Public Works Project No. 14-011-C1
New Unit Building/INDOT
Loogootee, Indiana

ADDENDUM NO. 1

ADDENDUM NO. 3

ADDENDUM NO. 4

LIFT STATION ELECTRICAL & PLAN/PROFILE
DATE: **04.07.15**
DRAWN BY: **C-1102**
SCALE: **0-4**

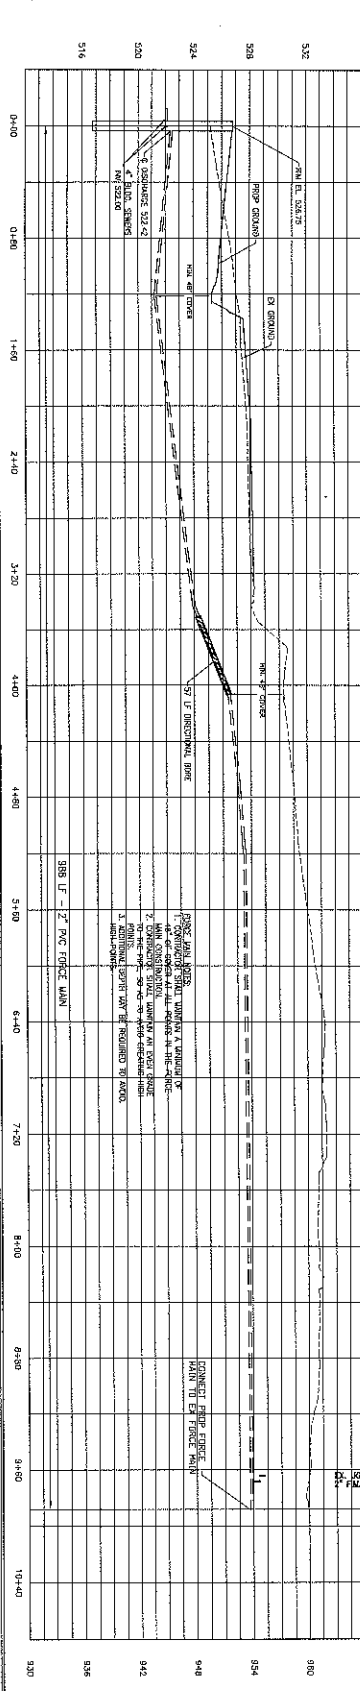
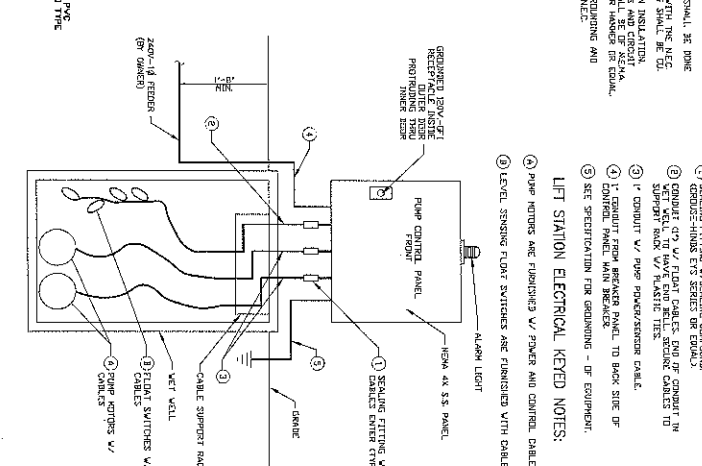
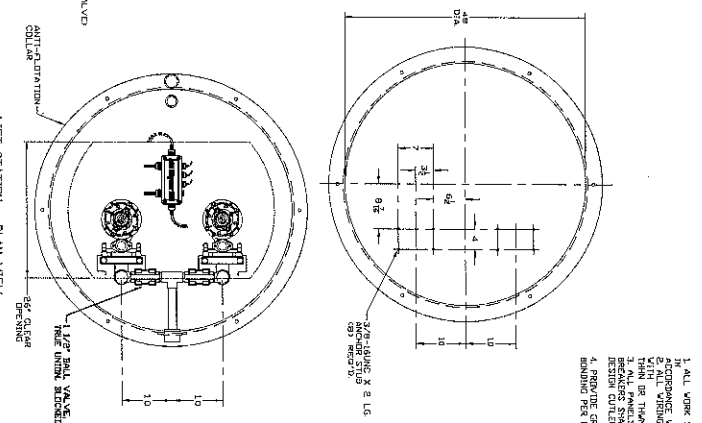
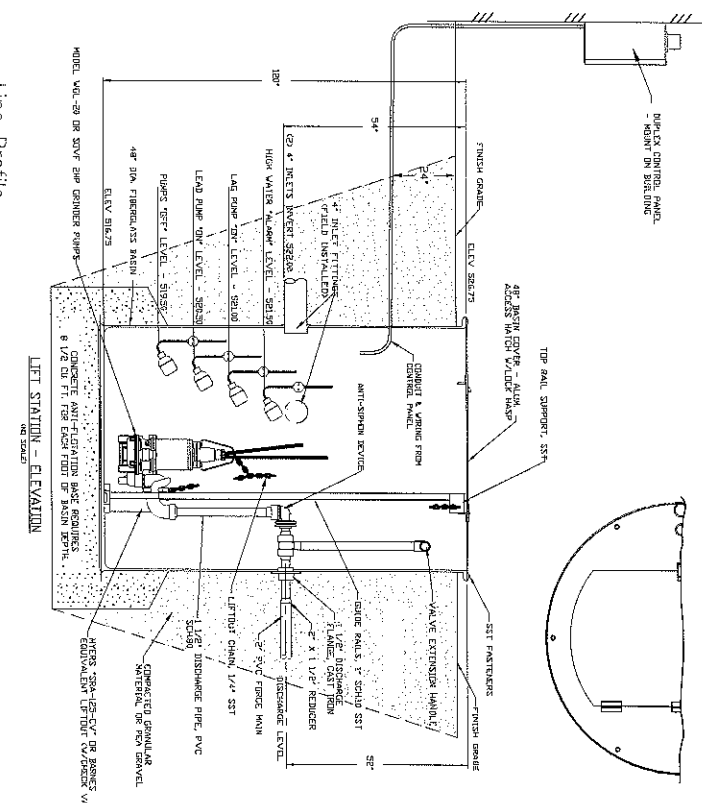
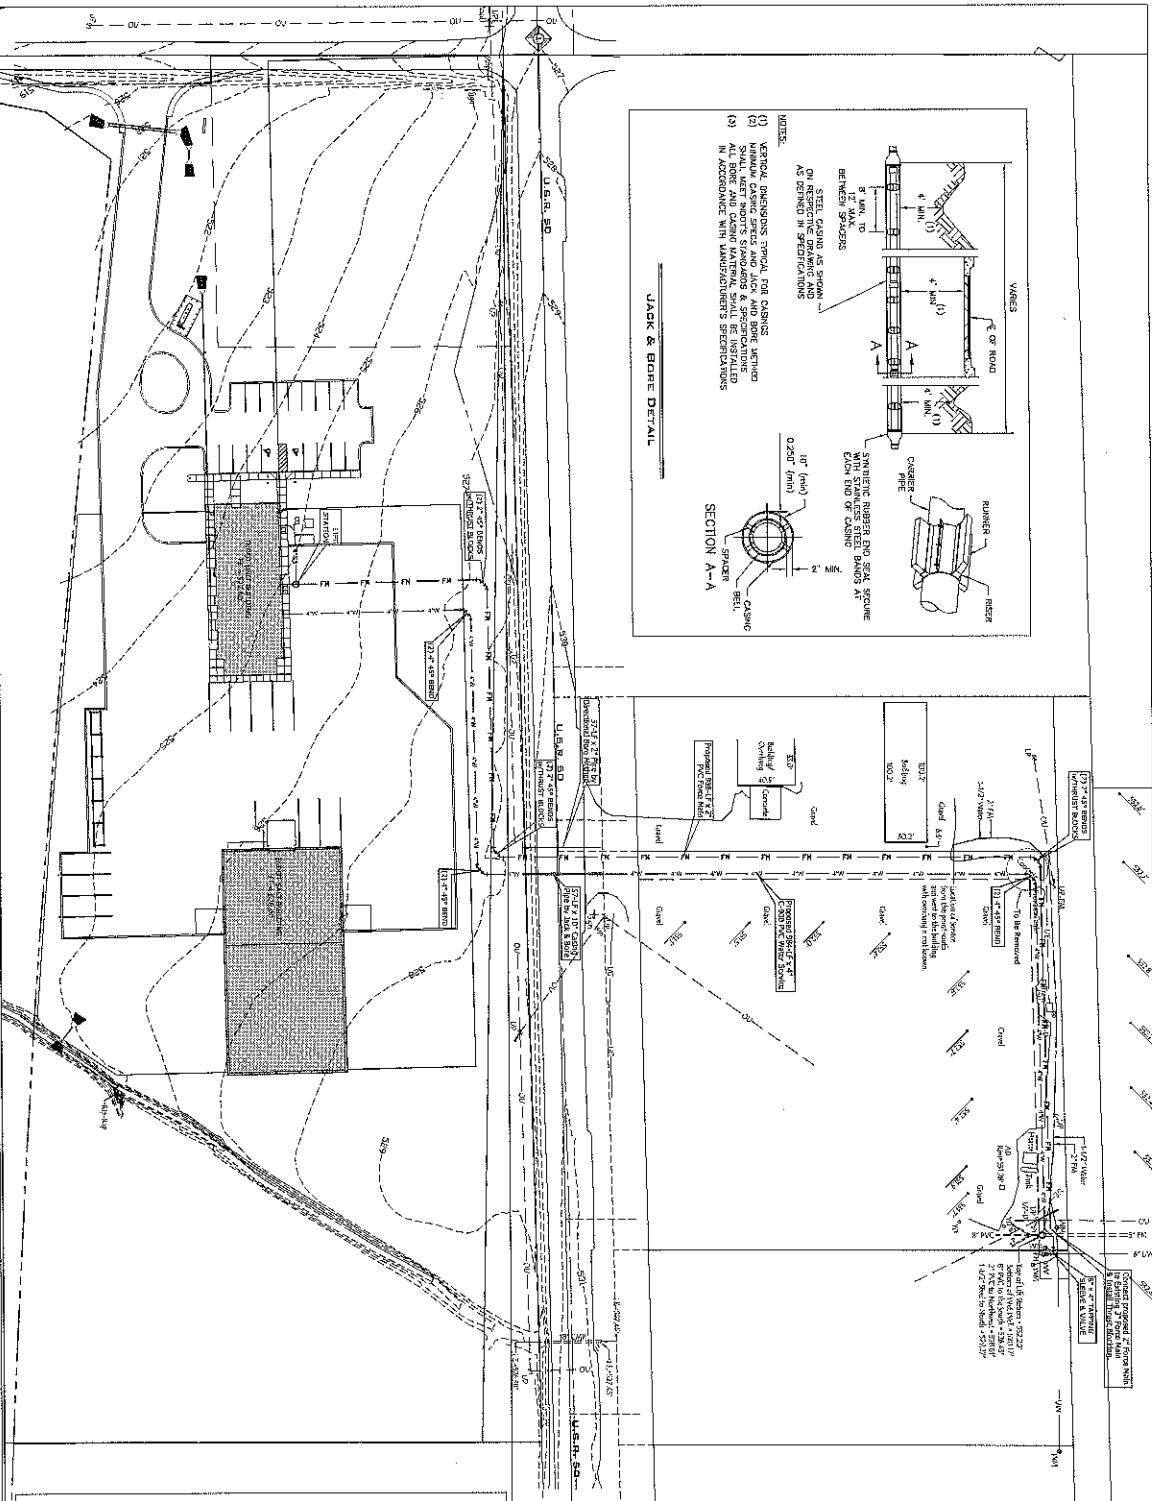
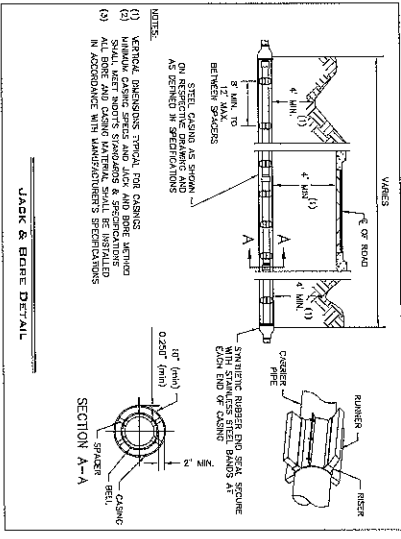
Replace Sheets C-101, C-102 and C-103 with attached sheets C-101, C-102, C-103 and C-104.
